## TECHNICAL MEMORANDUM

**PROJECT:** Salinas Valley Seawater Intrusion Model

**SUBJECT:** 2023 Model Updates to Address Groundwater Technical Advisory Comments

Figure 16. Model Hydrogeologic Zonation in Cross Section B-B'

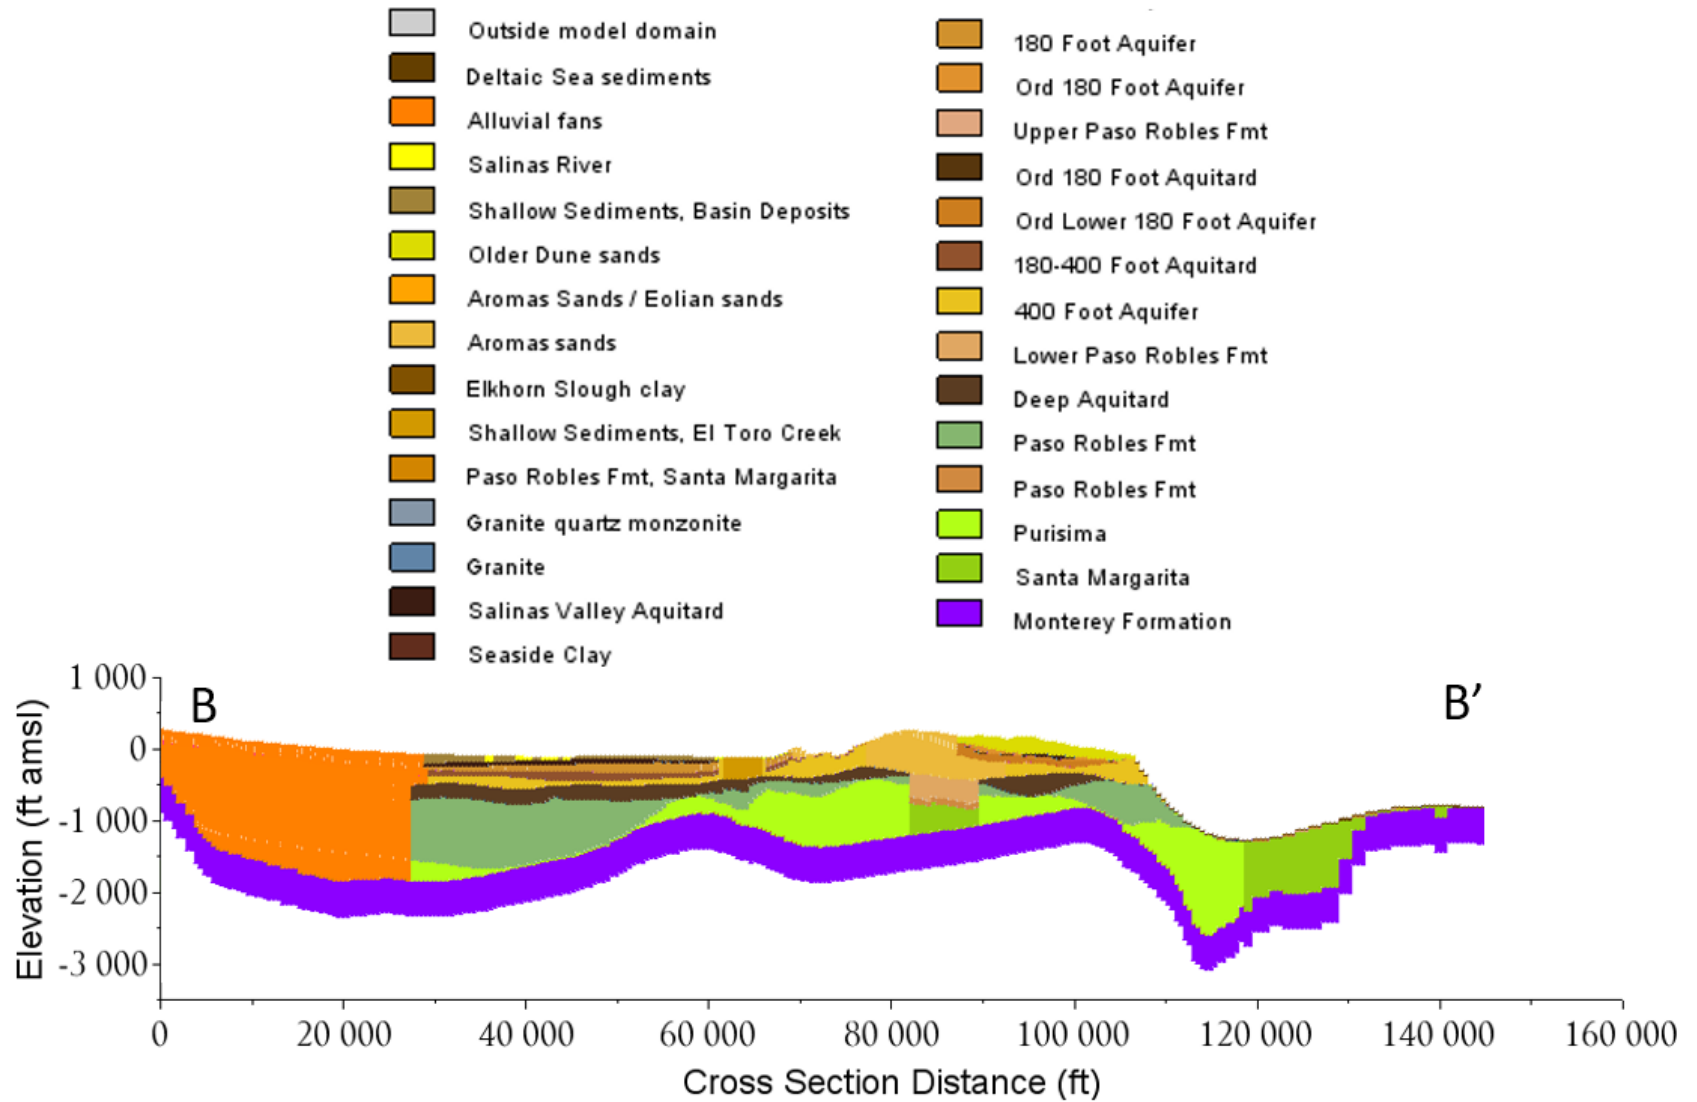
3. Adjust Monterey Formation uplift in the Monterey Subbasin based on more recent data

Previous geologic cross sections showed the Monterey Formation, which is considered the bottom of the groundwater basin, uplifting near the boundary between the Monterey Subbasin and the Seaside Subbasin. However, more recent geologic investigations show the Monterey Formation is located at greater depth and the GTAC recommended adjustments be made to reduce the uplift.

M&A adjusted the hydrostratigraphic units represented through the model layering and hydraulic parameter zonation in this area to reflect more recent understanding of the basin geology. The uplift of the Monterey Formation between the Monterey Subbasin and Seaside Subbasin was reduced by modifying the parameter zonation of the Monterey Formation in this area (zone 90) in the subject layers 7 through 10 to reflect the surrounding zones (400-Foot Aquifer, Deep Aquitard, Paso Robles Formation, and Purisima Formation). Then the elevations of layers 7 through 10 were adjusted to extend the surrounding formations through the area where the uplift had previously been delineated in the model.
